VCS VERIFICATION REPORT

YANGCUN HYDROPOWER STATION PROJECT (VCS PROJECT ID: 77)

Prepared by: Shenzhen CTI International Certification Co., Ltd
Report No.: CTI/NB-2013-1105-02
Rev. No.: 01
Date: 6 January 2014

Simplified diagram of main electric connection

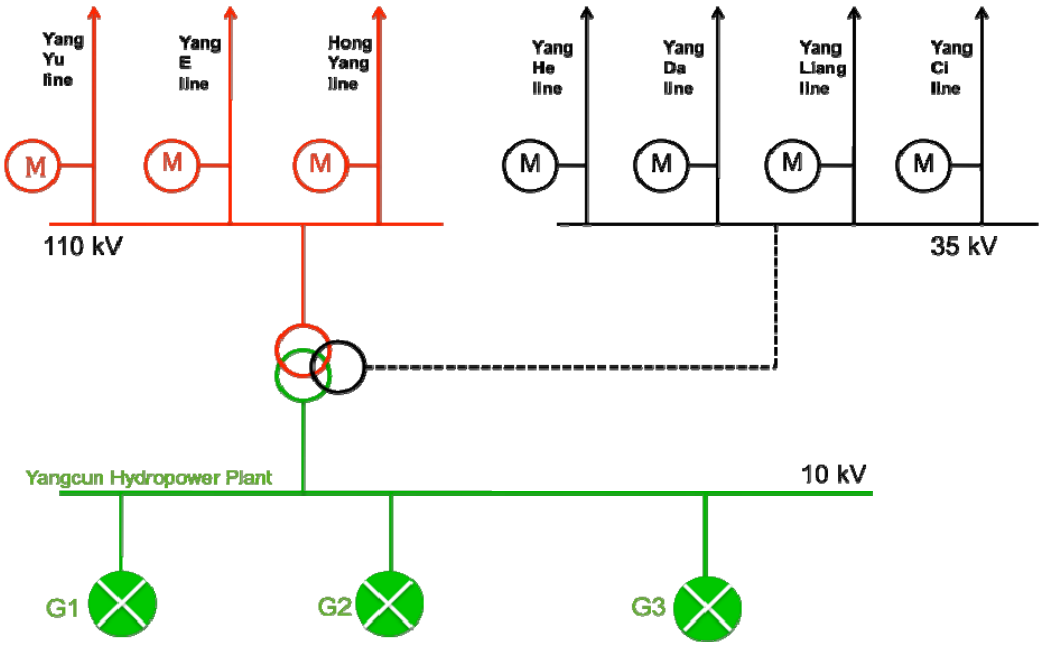
The meters M1 to M7 and meters for generators have been installed in accordance with the revised monitoring plan. CTI has on-site checked the location of the meters against the diagram of power connection system and found them to be consistent.
